Errata to **MPC107 PCI Bridge/Memory Controller User's Manual, rev. 0**

This errata describes corrections to the *MPC107 PCI Bridge/Memory Controller User's Manual*, rev 0. For convenience, the section number and page number of the errata item in the user's manual are provided.

Figure 3-3. PCI I/O Master Address Map B

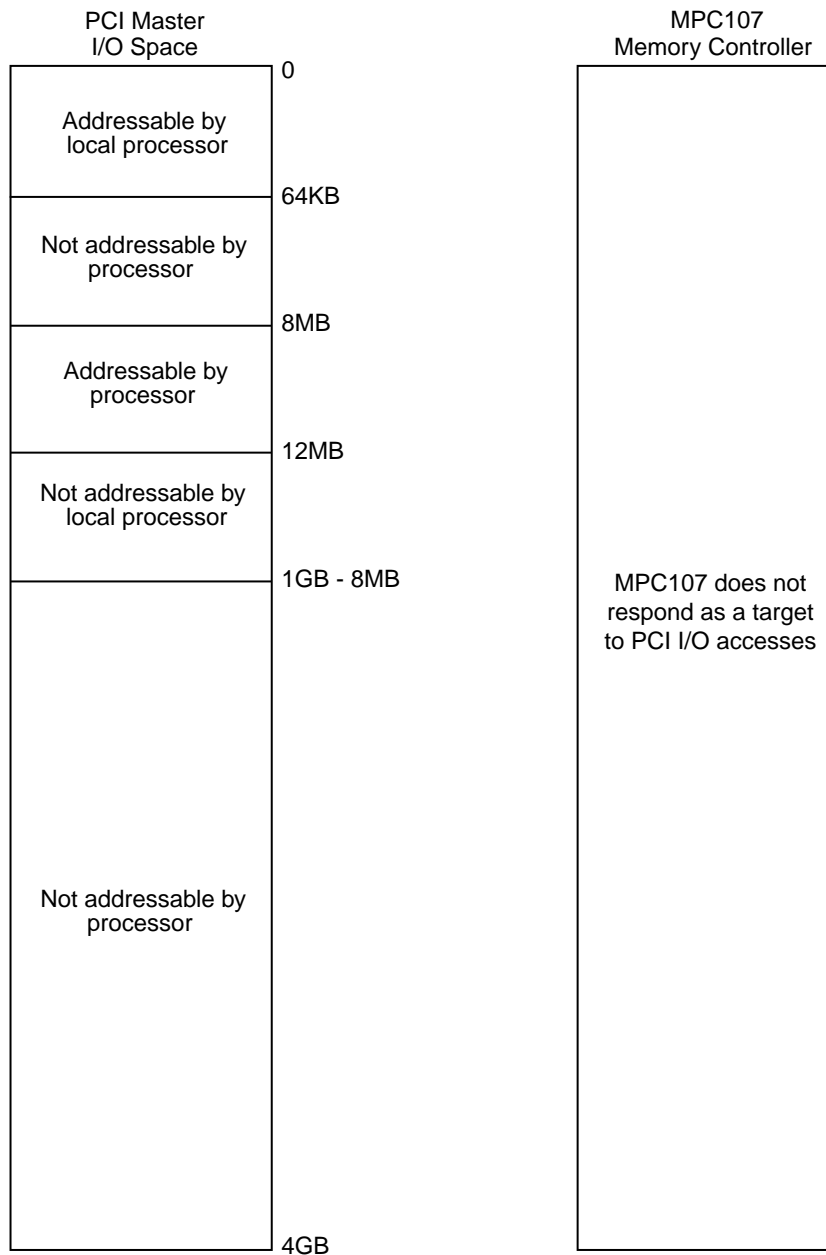
3.1, 3-7

Replace Figure 3-3 with the following:

Figure 4-30. Memory Control Configuration Register 2 (MCCR2)—0xF4

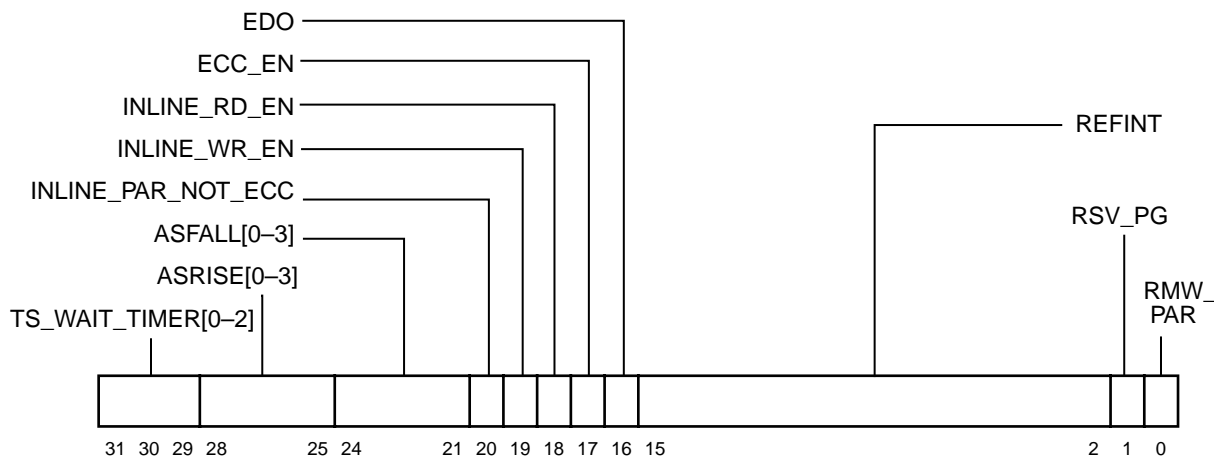
4.10, 4-47 Replace Figure 4-30 with the following. Note the name change to bit 18.
